Item 3.**Development Application: 161 Castlereagh Street, Sydney - D/2019/88**

File No.: D/2019/88

This proposal is recommended for refusal.

Figure 12: Proposed plan. Tenancy numbers also labelled on plans.

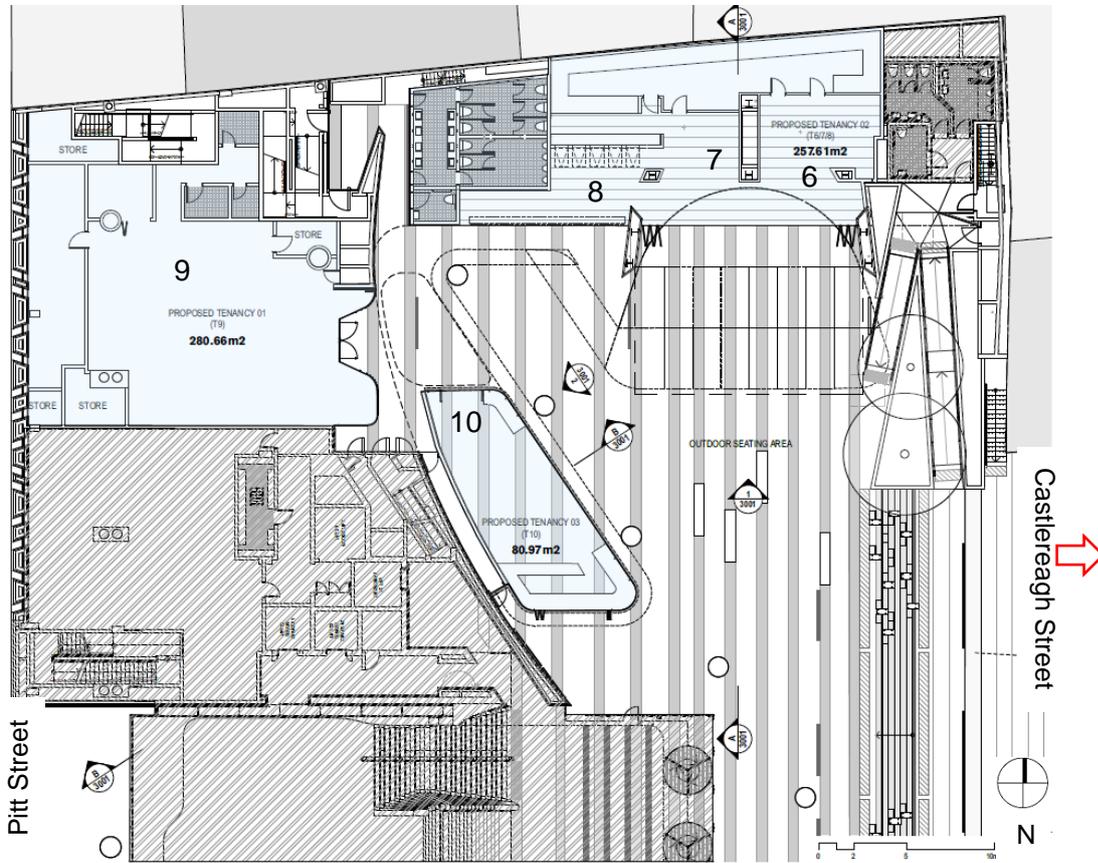
The proposal extension of the leasable seating area is not supported as it will privatise the public space reducing the quantity and quality of the public space which is contrary to the intention of the base consent and the covenant. The pavilion building will negatively impact on views to the existing public art installation and the existing bench seating will be removed.

- (B) The proposal reduces the amount and quality of the useable open space available to the public in the plaza. The leasable seating zone, for the exclusive use of pub, is extended with a continuous awning over the outdoor seating area. This will result in a large portion of the plaza being privatised.

Figure 13: Proposed awning plan.

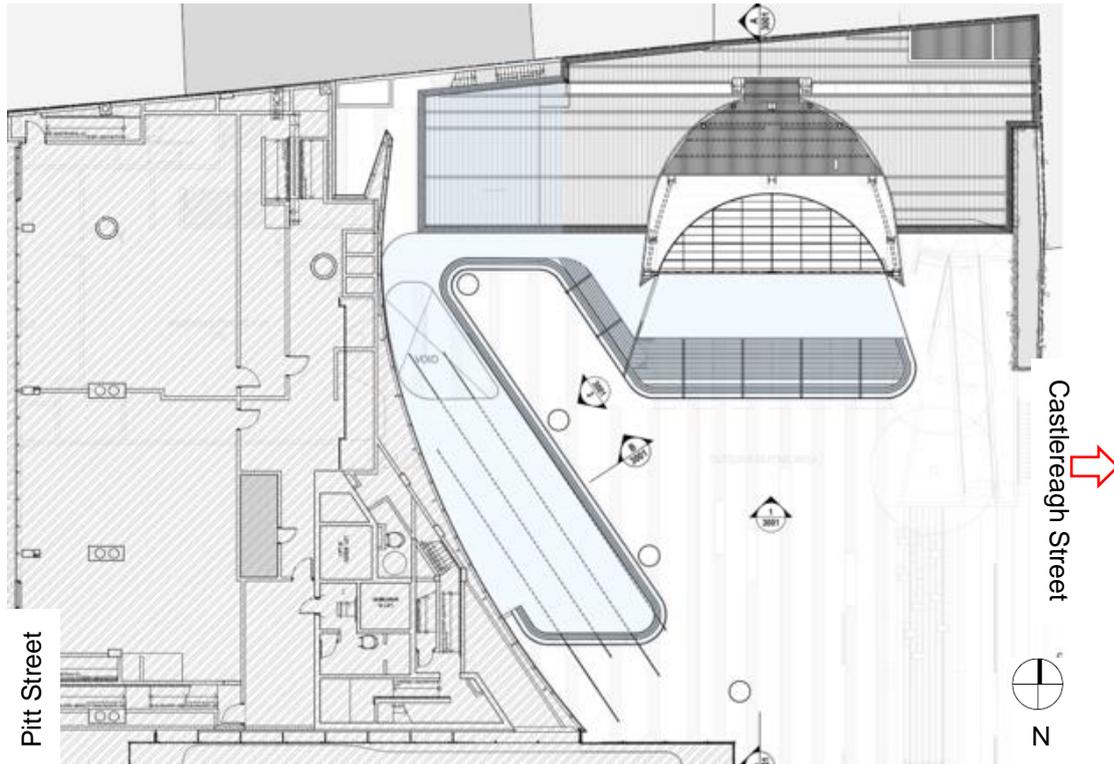
- (F) The proposal fails to comply with provision 3.5.2 of the Sydney DCP 2012. The proposed awning will encroach significantly on the canopy of the semi-mature hills fig tree located in a planter box on the eastern side of the plaza.

Figure 14: Proposed pavilion section (tenancy 10).

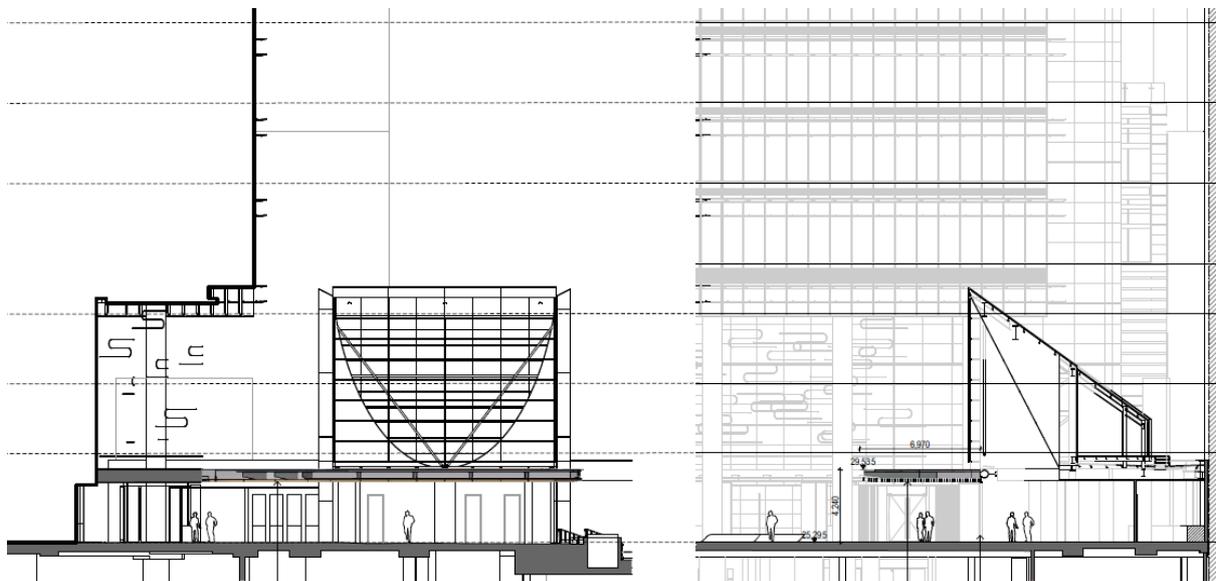
- (D) The new bar known as tenancy 3 will almost entirely encompasses the buildings undercroft and will negatively impact on views and the space around the existing public art installation. The proposal is contrary to the objectives of provision 3.1.5 (public art) of Sydney DCP 2012 which includes a requirement to improve the quality of public artworks in private developments and ensure that public art is an integrated and cohesive part of new development.

Figure 25: Proposed extended licensed boundary area.

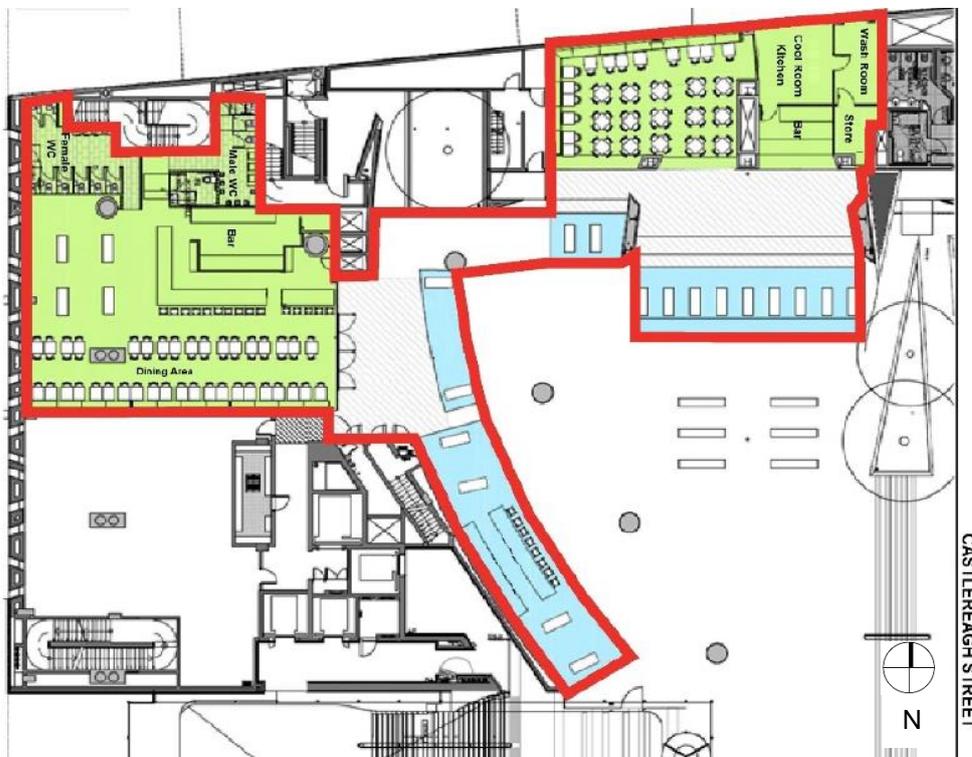
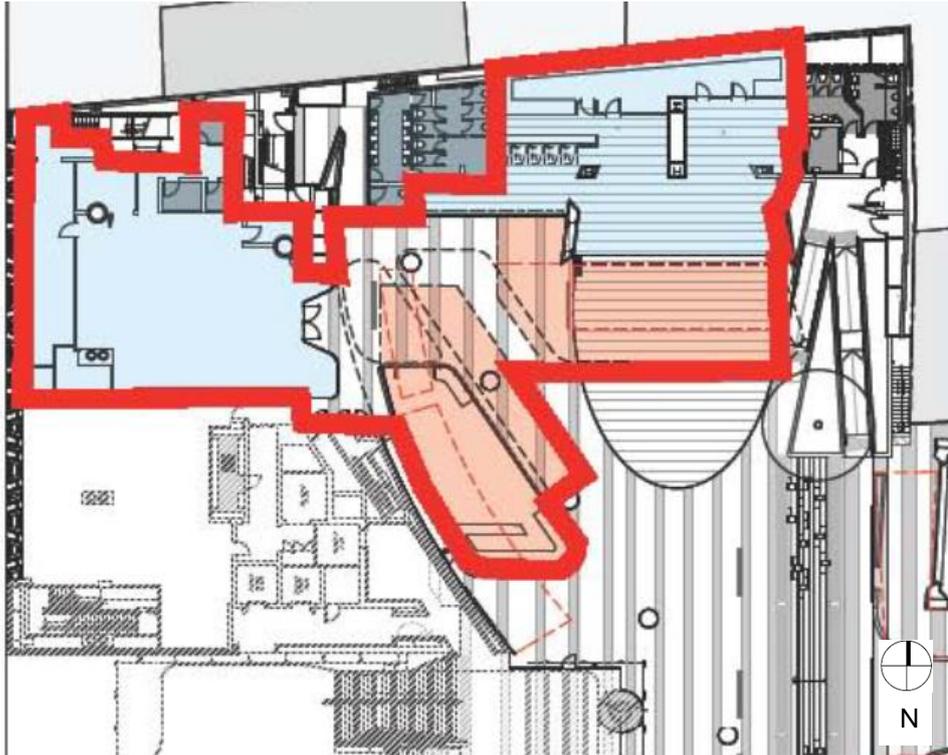
67. While the subject application does not seek to increase the patron capacity of the licensed venue it seeks approval for the extension of the liquor license boundary beyond the leasable seating areas and the approved liquor license boundary plan.

68. As such section 47G (restrictions on changing boundaries of Premises) apply. The existing approved licensed area floor plan is provided below in figure 24 and the proposed licensed area floor plan is provided in figure 25.

Figure 26: Approved and proposed Restriction on Land Uses Plan.

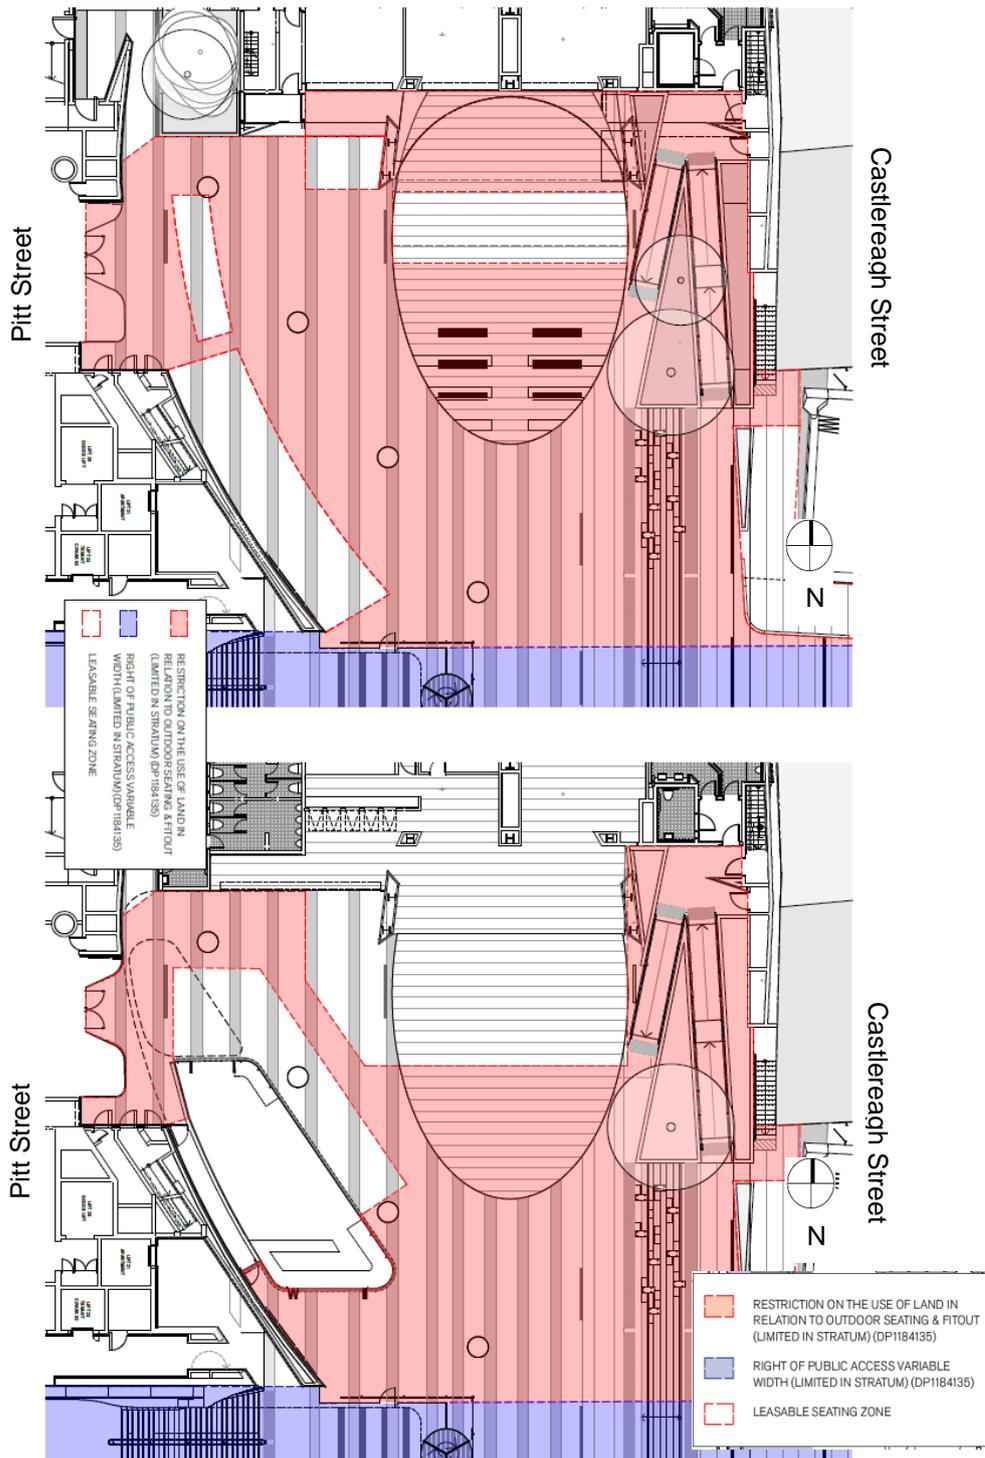
97. The proposal seeks consent to extend the private leasable seating zone and vary the restrictive covenant in relation to the use of land to allow for a larger outdoor dining area. Figure 26 below illustrate the approved leasable seating areas under the restrictive covenant and the proposed variation to the leasable seating zones. The plan is annotated to reference that the red area (the open space) in the approved plan equates to 971.15sqm - this is reduce to 748.19sqm in the proposed plan (a reduction of 222sqm).

- (a) A 222.96sqm reduction in the amount of 'public' space in the plaza. This loss is further exacerbated if the relatively narrow spaces leading to Tenancy 9 around the proposed private outdoor spaces (see figure 27 below), which effectively is only usable for circulation purposes, were excluded;

Figure 31: Elevation and section of the proposed pavilion to tenancy 10.

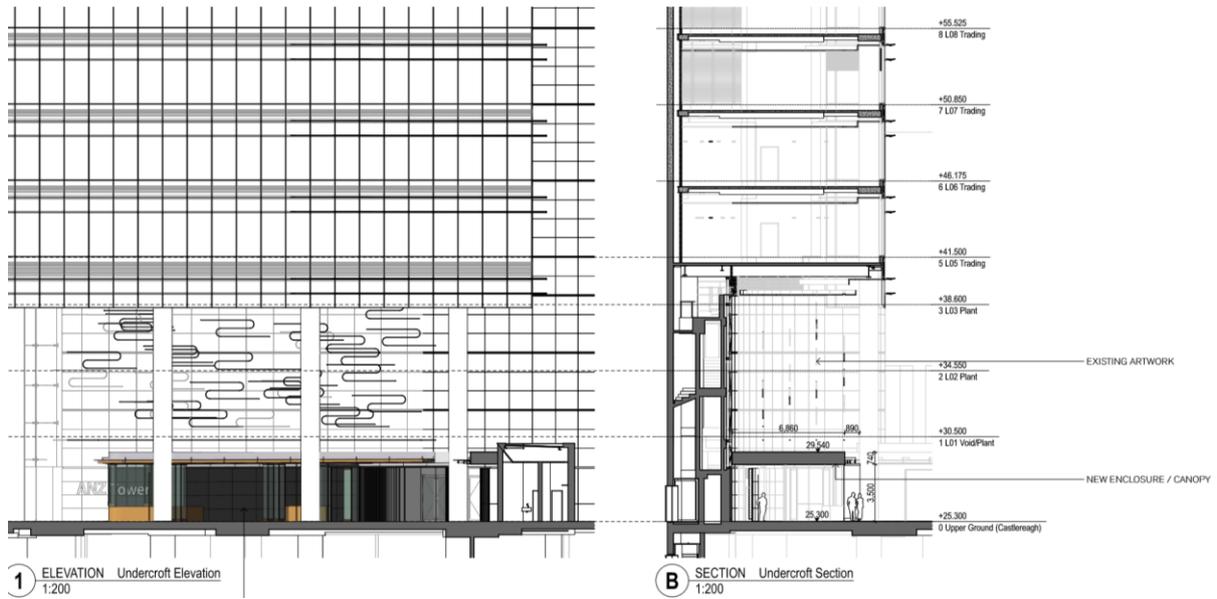
92. Further, the argument that the proposed development does not add any additional bulk to the development is not supported. The existing public plaza is surrounded by a small pavilion addition and a large undercroft area approximately 13.8m in height that supports a piece of public art. The proposal seeks to add additional pavilions that both add bulk to the otherwise large open plaza and impacts views to the artwork and existing pavilion.

113. The proposed pavilion is located immediately below the under croft and the art installation, refer to figures 31 and 32 below.
